TECHNICAL DEFICIENCIES RESPONSE LETTER

June 10, 2024

***Re: Technical Deficiencies Responses for the Phase IV Pipeline
DEP Joint Permit File No. E4129223-006 / APS No. ID No. 1096604***

SHEET 3 OF 5
JOINT PERMIT APPLICATION
SITE PLAN
PHASE IV PIPELINE
Cummings & McHenry Townships, Lycoming County
Pennsylvania General Energy Co., LLC, Warren, PA
Prepared By:
BERAN
ENVIRONMENTAL SERVICES
Boyers, PA 724-735-2766
September 2023

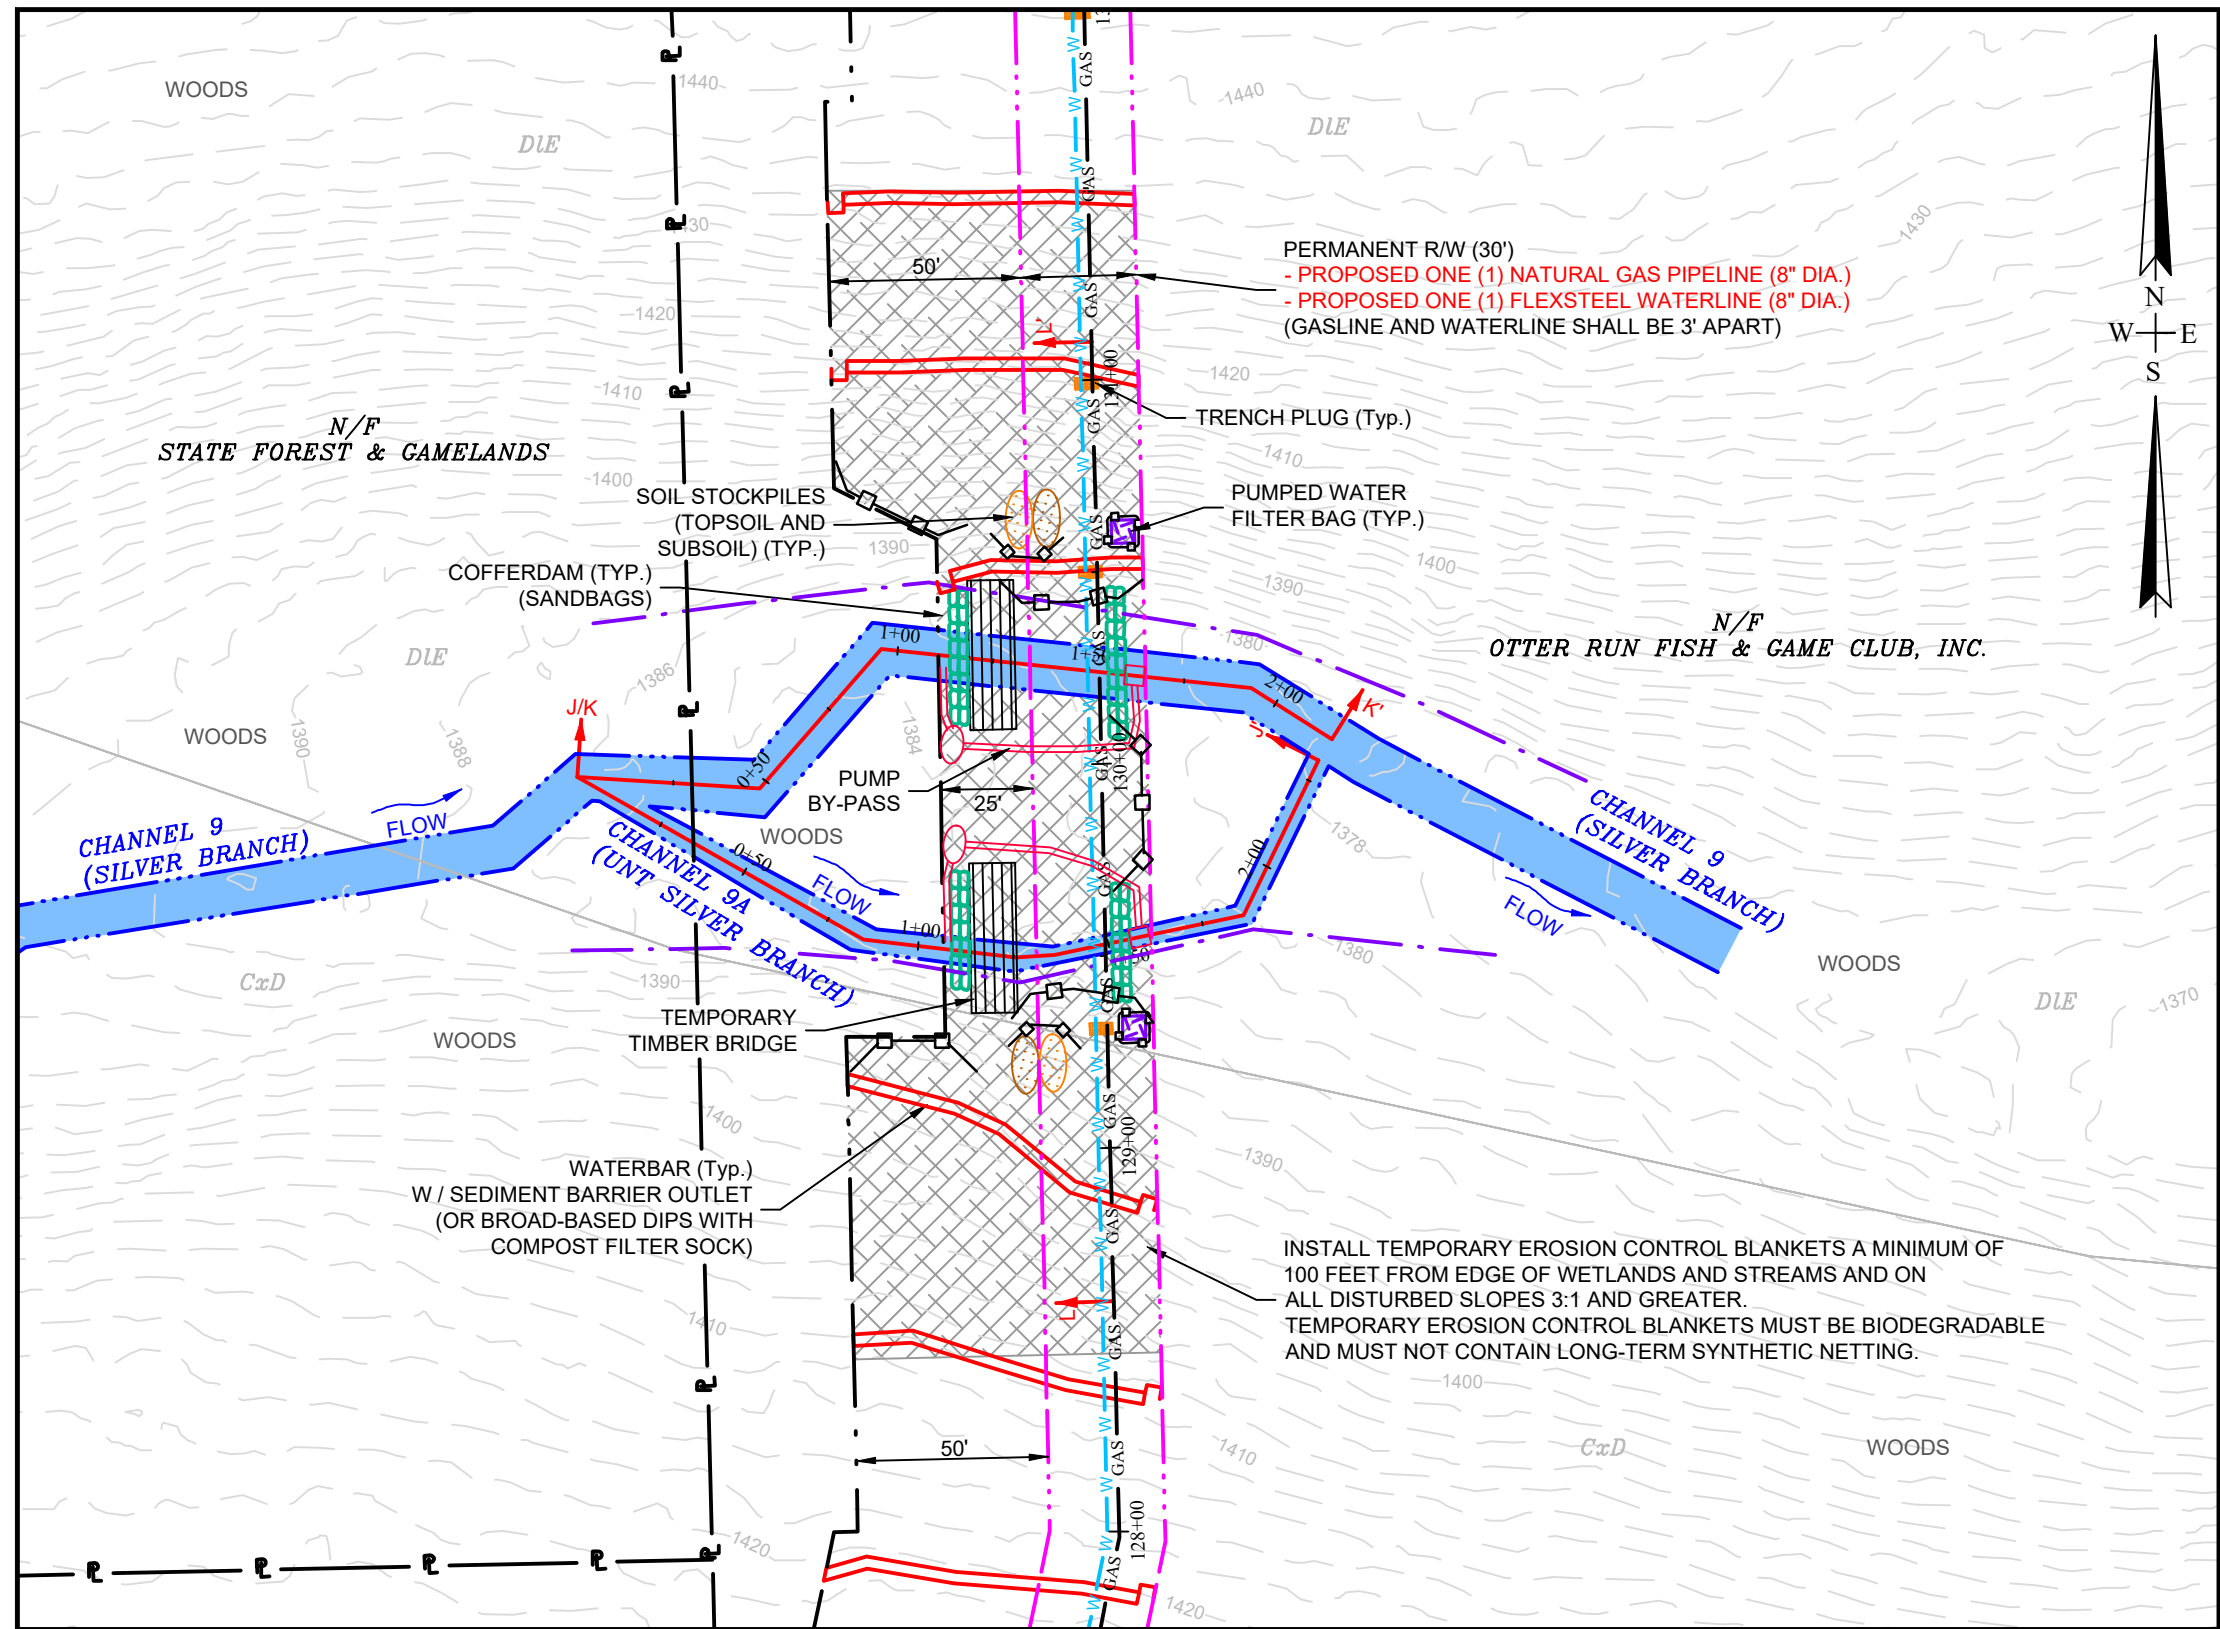
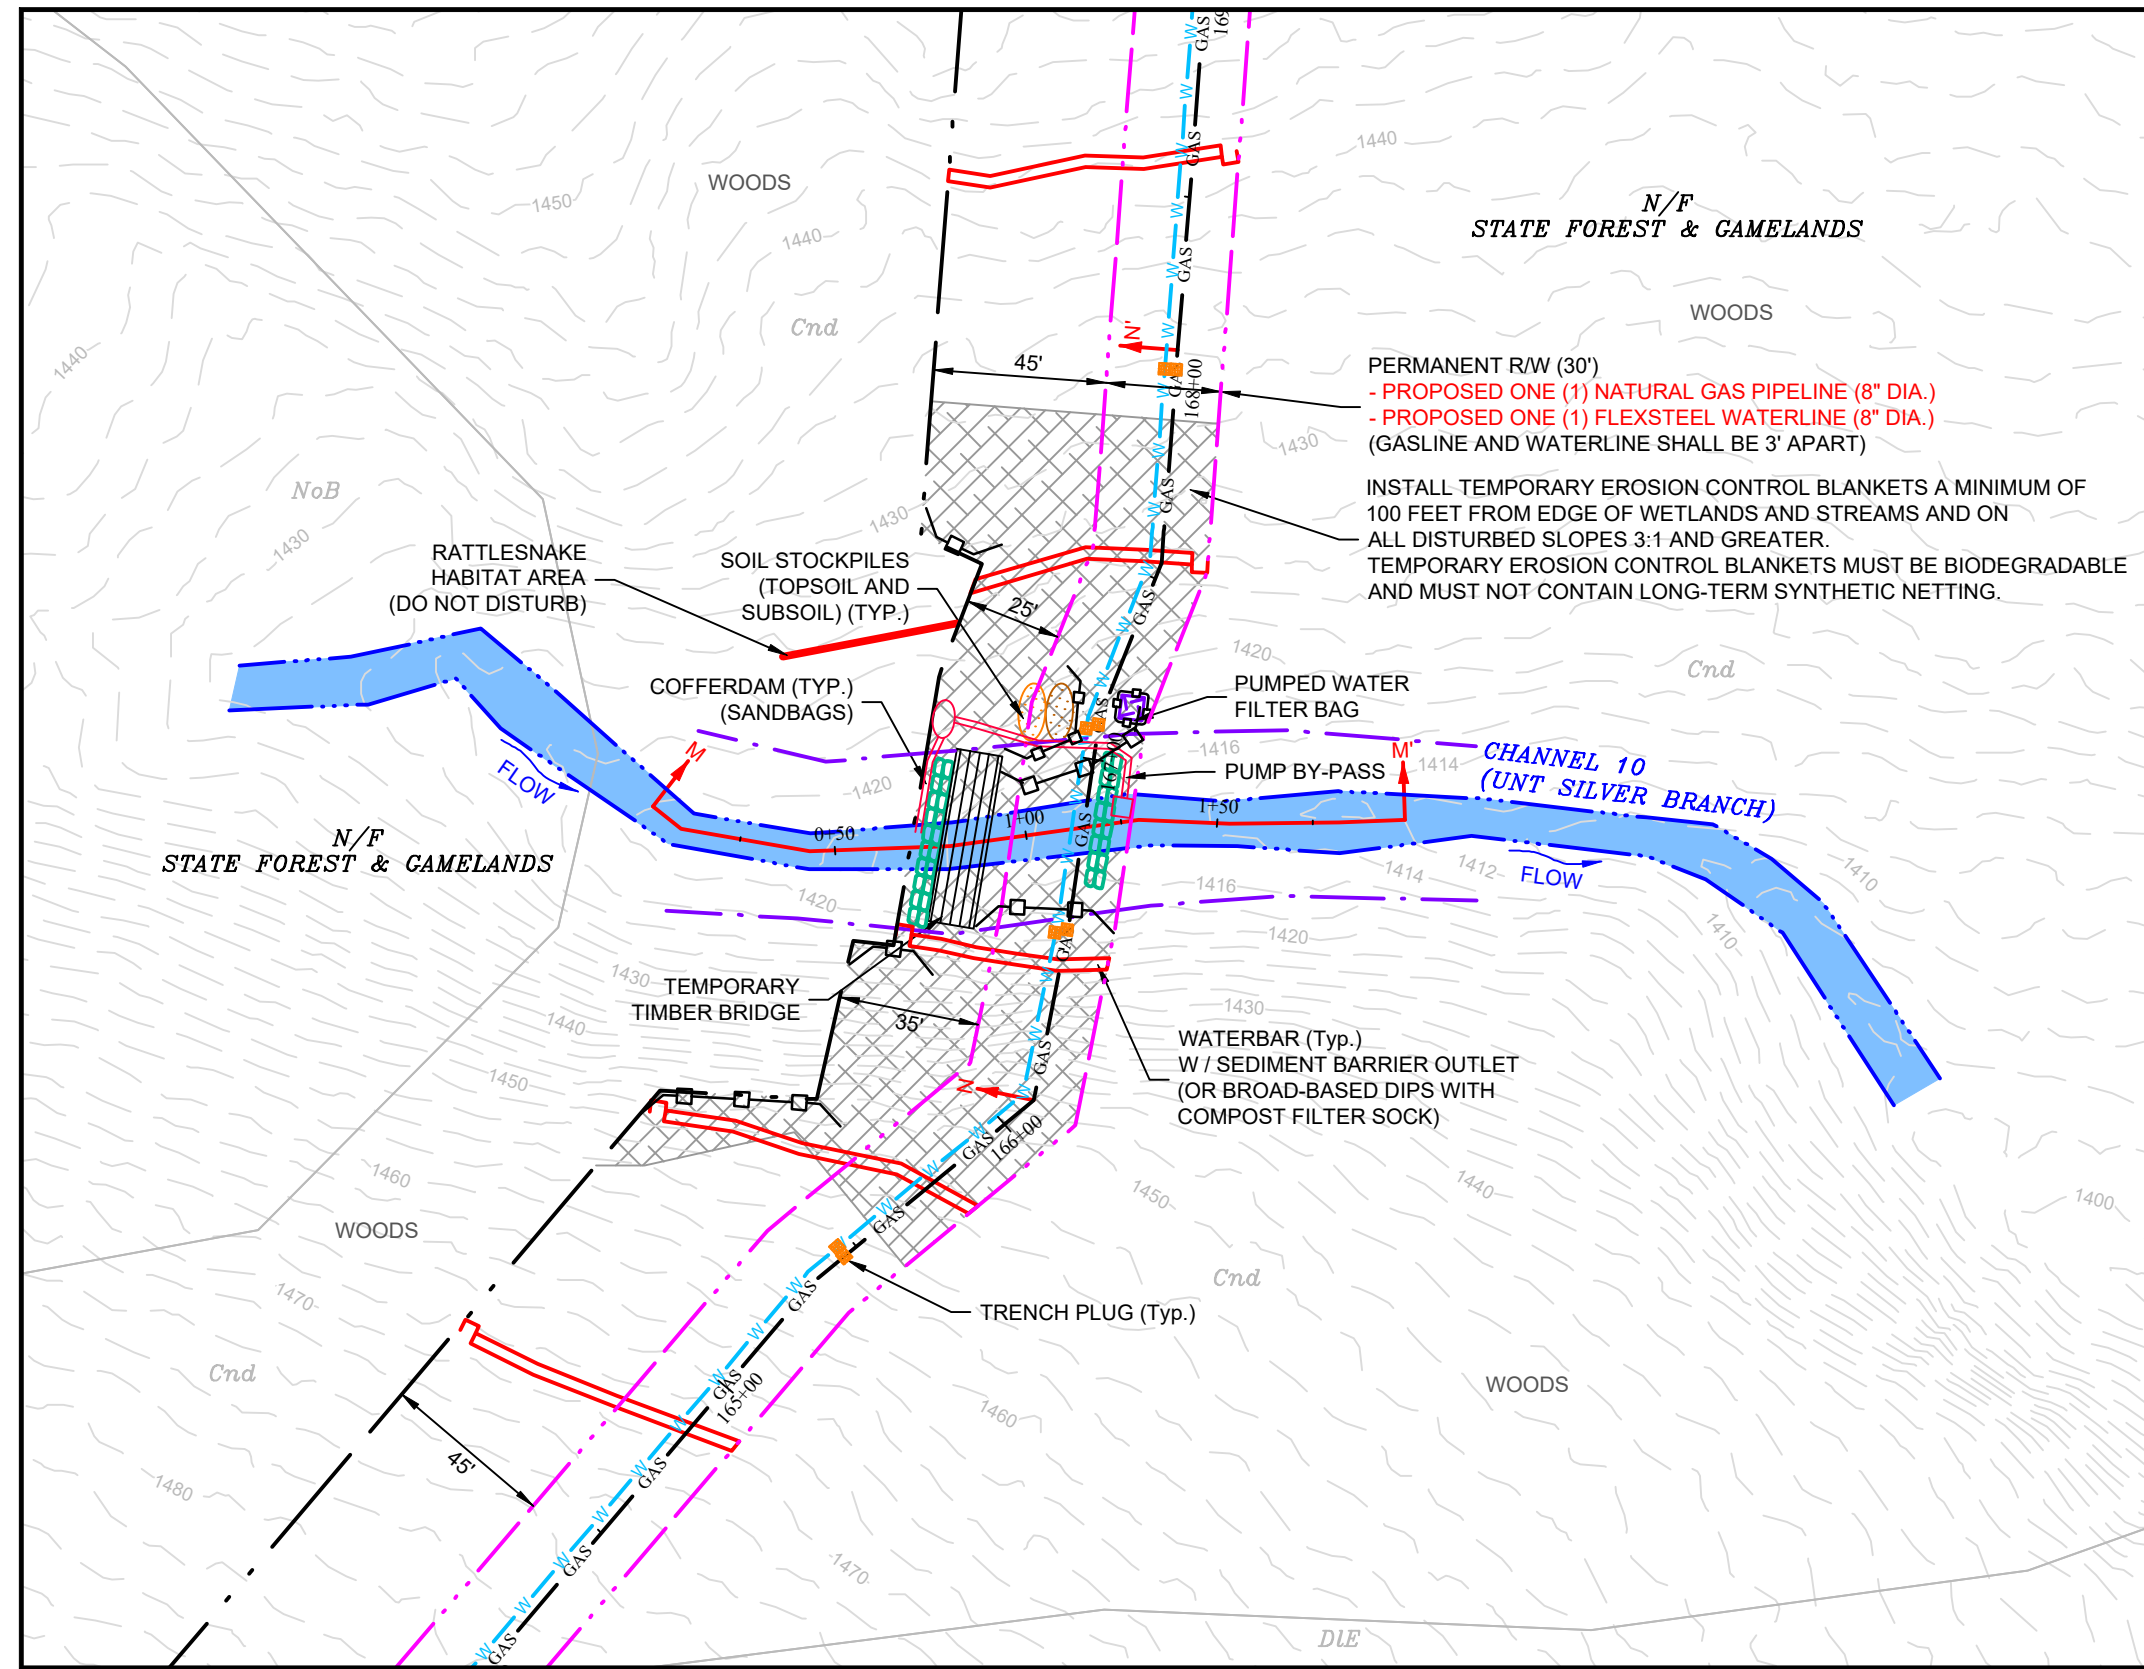
3. The Class A wild trout note is still missing from Table S.2.B. 1-5 and various tables in the Environmental Assessment Form. Ensure that all tables are updated to accurately reflect the Class A wild trout stream designation. 105.13(e)(1)(i)(A)

The Class A wild trout note has been added and all tables have been updated.

NOTE: SILVER BRANCH AND ITS TRIBUTARIES ARE LISTED AS CLASS A WILD TROUT STREAMS. THEREFORE, NO CONSTRUCTION OR FUTURE REPAIR WORK SHALL TAKE PLACE IN OR ALONG THE STREAM CHANNELS BETWEEN OCTOBER 1 AND APRIL 1 WITHOUT PRIOR WRITTEN AUTHORIZATION FROM THE PENNSYLVANIA FISH AND BOAT COMMISSION.
